## MEMORANDUM

**FILE NO:** Plan Change 76 – Wakefield Residential Growth

**RE:** Indicative Reserves and Walkways

Figure 2 – TRMP Areas Map 76/1 – Recommended amendments in response to submissions/further submissions

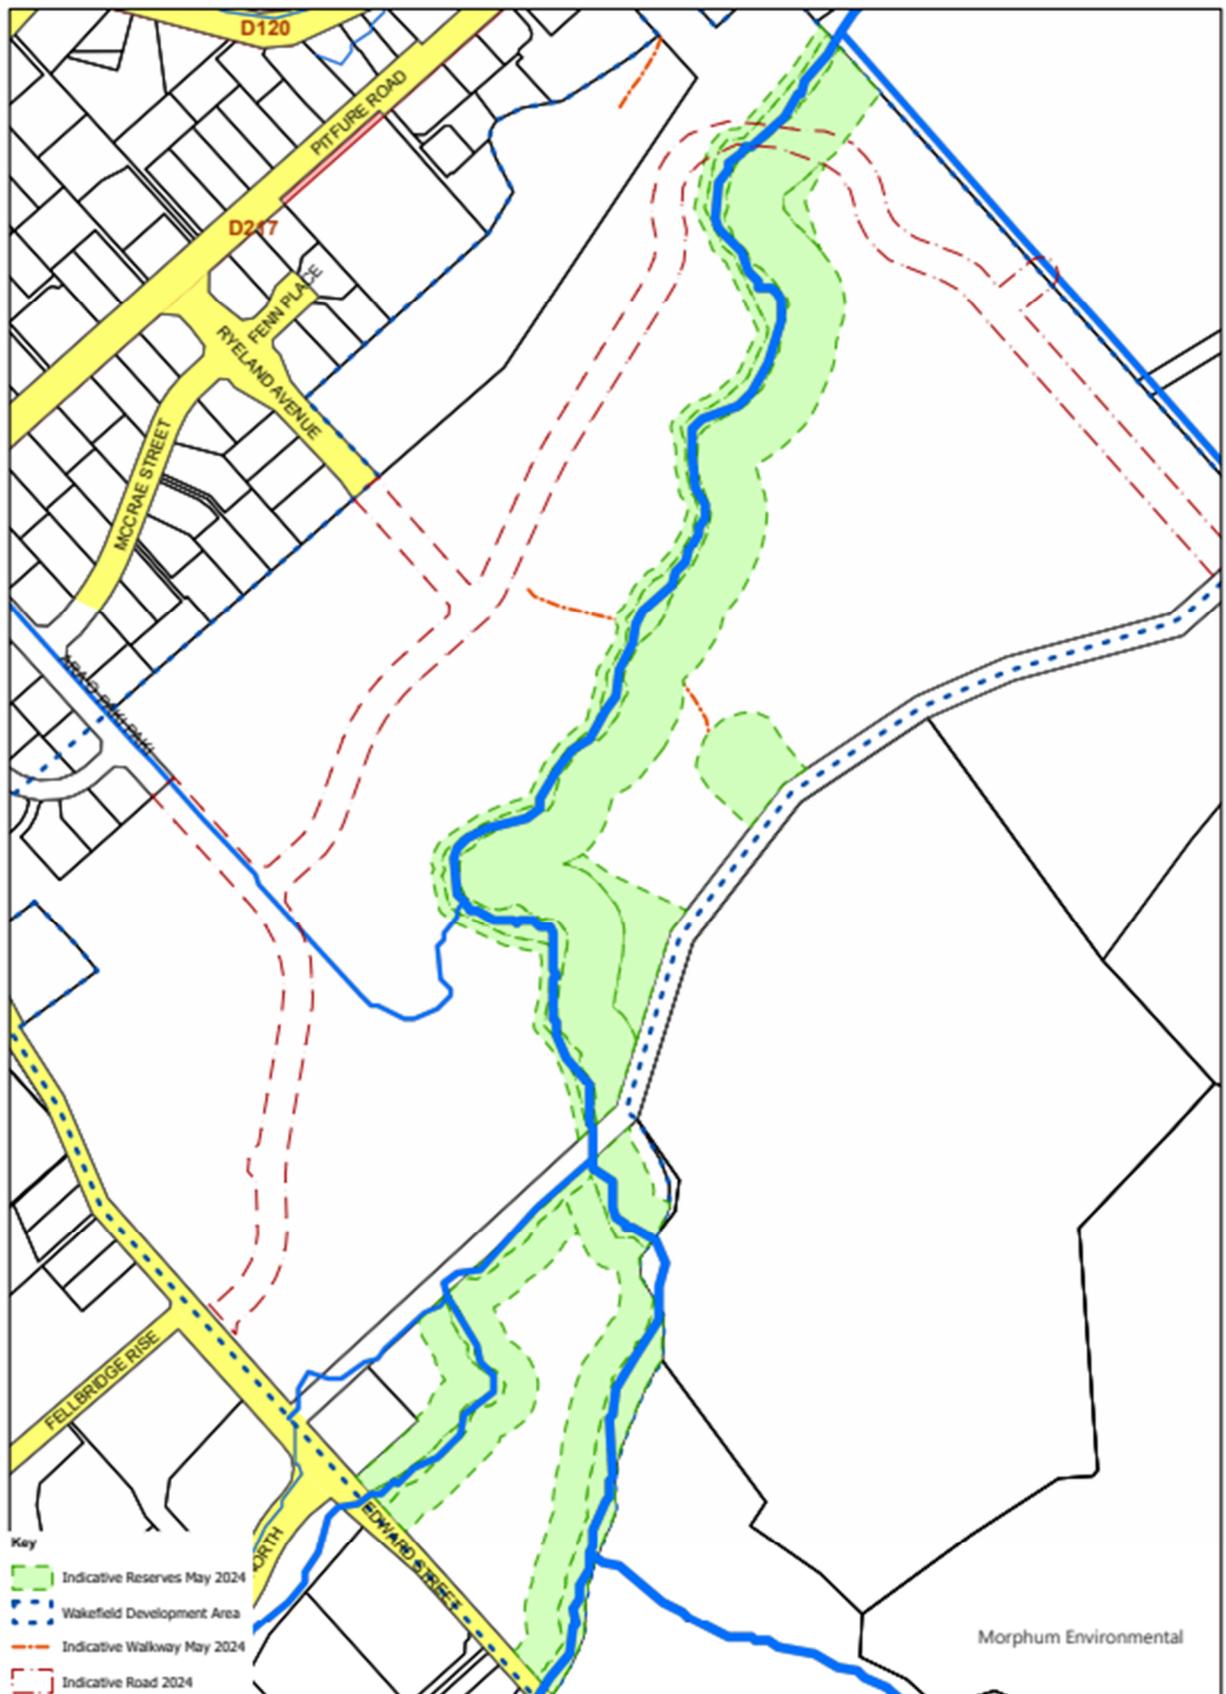
<p><u>Indicative Reserve - Left bank Pitfure Stream</u></p> <p>i) Retain the 20 metre indicative reserve notation on the left bank of the Jenkins and Pitfure Streams from the Edward Road boundary to Higgins Road Reserve (within the plan change site) – (See photograph 4).</p> <p>ii) Accept a reduction in the indicative reserve notation on the left bank of the Pitfure Stream from Higgins Road to the northern boundary of the plan change area to provide for a 6 metre wide level area of land from the top of the bank (being the existing or future bank following earthworks/land recontouring associated with a suture subdivision). The reason for this is to enable the efficient use of the residential land while providing a 6 metre wide corridor at the top of the bank for maintenance vehicle and public access, planting and erosion control;</p> <p><u>Indicative Reserve – Right Bank Pitfure Stream</u></p> <p>iii) Increase the 20 metre width of the indicative reserve notation on the right bank of the Pitfure Stream from Higgins Road to the northern boundary of the Plan Change area by up to 14 metres (making a total width of up to 34 metres) to reflect the reduction of the indicative reserve from 20 to 6 metres adjoining from the top of the left bank (being the existing or future bank following earthworks associated with the subdivision) – The reason for this is to provide a wider esplanade reserve on the right bank which has a more favourable topography and connectivity for multiple recreational, flood hazard and environmental uses (Refer to photograph 5);</p>

<p><u>Rule</u></p> <p>iv) Include additional text in Rules 16.3.3.1 9n) (iii)(c), 16.3.3.1B (f) (viii) to specify that no credit against the reserve financial contributions will be provided for the additional (up to 14 metres) Local Purpose (Esplanade) Reserve width (above 20 metres) on the right bank of the Pitfure Stream, required in lieu of the reduction in the width of the Local Purpose (Esplanade) Reserve on the left bank.</p> <p>The reason for this is to ensure that Council is not providing additional reserve financial contribution credits for land that could be vested without a credit on the left bank;</p> <p><u>Indicative Reserve adjoining Ryland Avenue</u></p> <p>v) Decline the proposed additional indicative reserve adjoining the northern boundary of Ryland Avenue shown below but include a 6 metre wide indicative walkway – The reason for this is due to the vesting of large areas of reserve adjoining Pitfure Stream, the group of Totara Trees and mature Oak tree and existing reserves within previous development in the vicinity. Council is exceeding its level of service for reserves and does not consider that an additional reserve is needed in this location;</p>

<p><u>Reconfiguration of Existing Indicative Reserve</u></p> <p>vi) Accept the reconfiguration of the location and shape of the indicative reserve to the east of the indicative esplanade area shown below (Refer to photograph 6);</p>
--	--	--	--

<p><u>Indicative Reserve around Mature Oak Tree</u></p> <p>vii) Accept in part the proposed amendments to the indicative reserve notation in the vicinity of the mature Oak tree (Refer to photographs 7 and 8) to provide a frontage to Higgins Road, but also to extend the indicative reserve boundary to 10 metres from the dripline of the tree (Refer to photograph 9).</p>
--	--	--	---

Figure 3 – TRMP Areas Map 76/1 – Proposed amendments requested in submission from Wakefield Village Developments

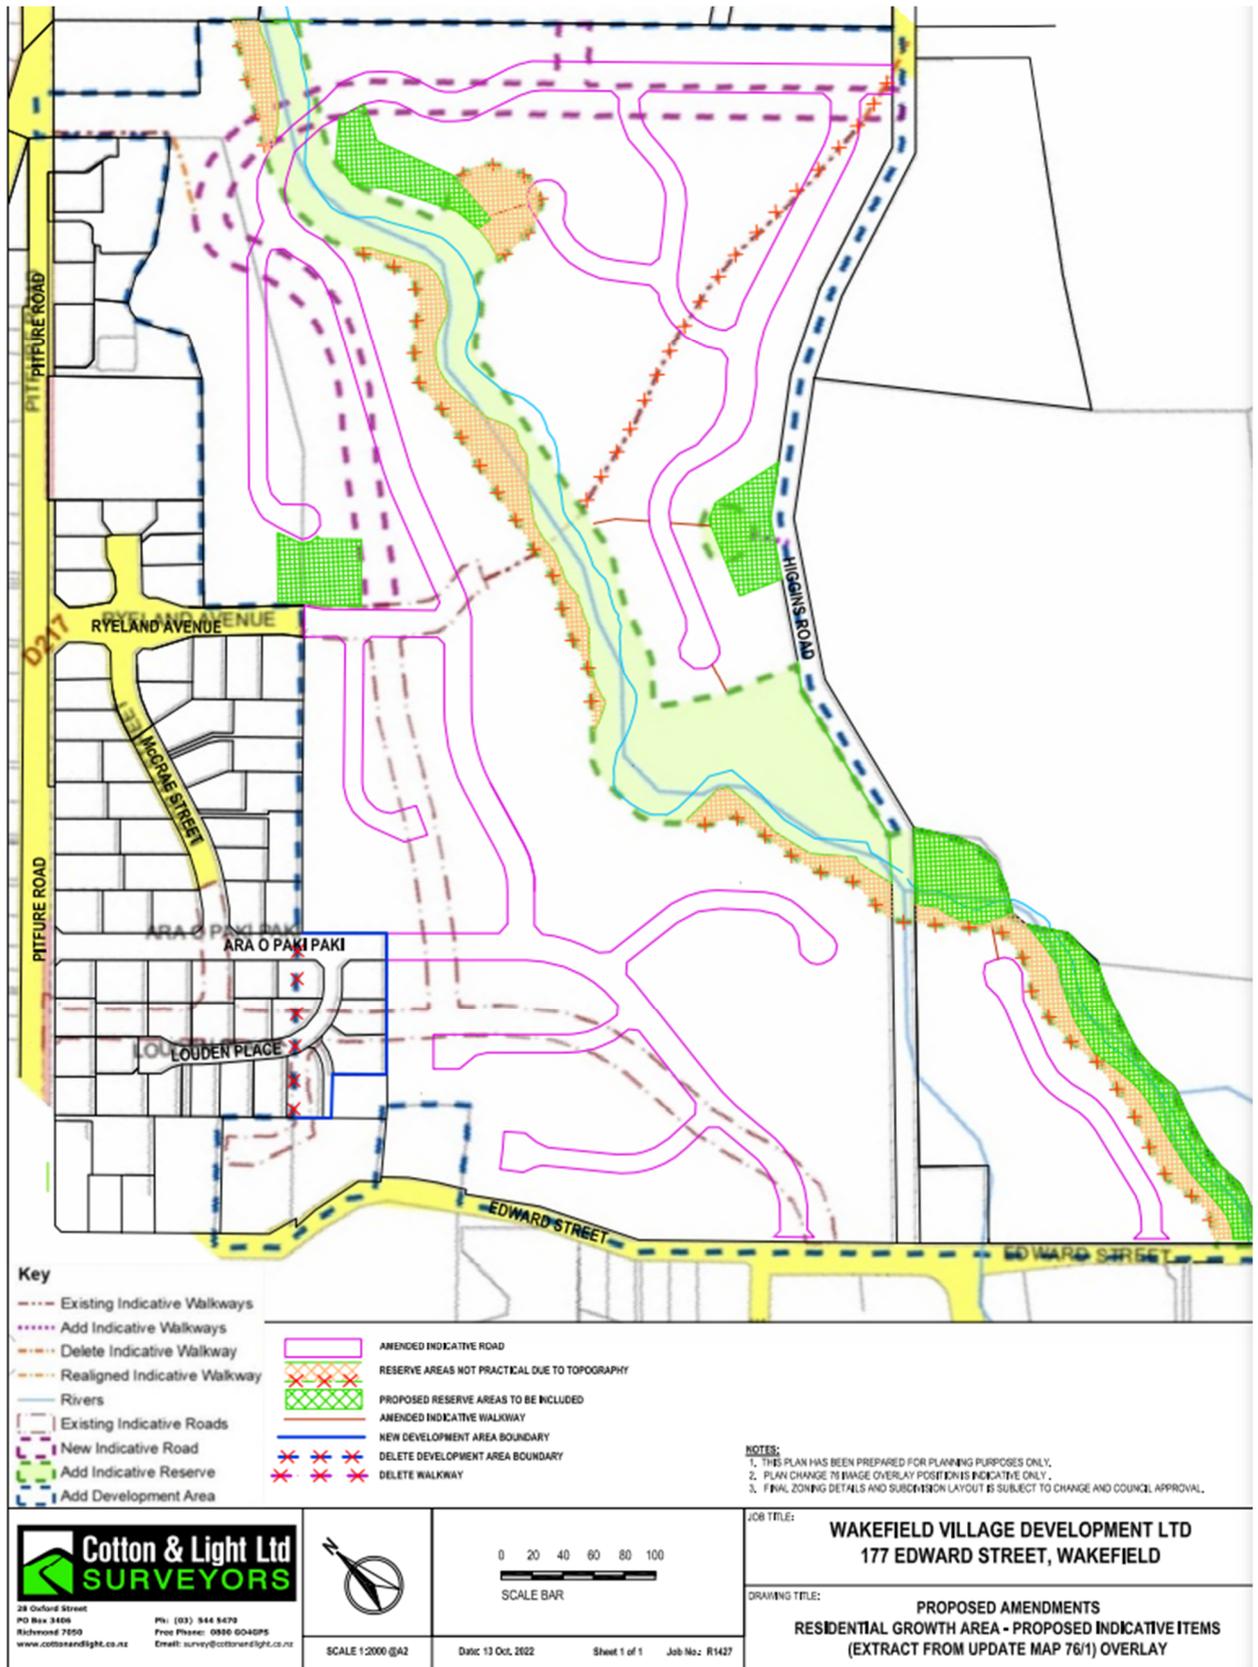
Daniel & Katherine McKay 4210 - 76.0-7	General (Maps 76/1)	Request inclusion of the existing stream.	No change – This appears to be a stormwater drainage feature not a stream and will be addressed by stormwater management when the site is subdivided
Wakefield Village Development Ltd 4211 - 76.0-9	General (Map 76/1)	Amendments sought: a) Amend alignment of the indicative walkways in response to the attached plans  c) Amend alignment of the indicative reserves in response to attached plans (Figure 2)	Amend Map 76/1 as shown in Figure 3 for the following reasons:  a) Accept realignment of the proposed indicative walkway connecting the extension to Ryland Avenue to Higgins Road as shown below. The proposed realignment will achieve (via the proposed walkway and roading network) the pedestrian/cycle connective being sought and include connectivity to the proposed reserve around the mature oak tree;

<p data-bbox="1093 1310 2018 1385">b) Amend the alignment of the indicative reserves and rule wording as shown and described as follows:</p>
--	--	--	---
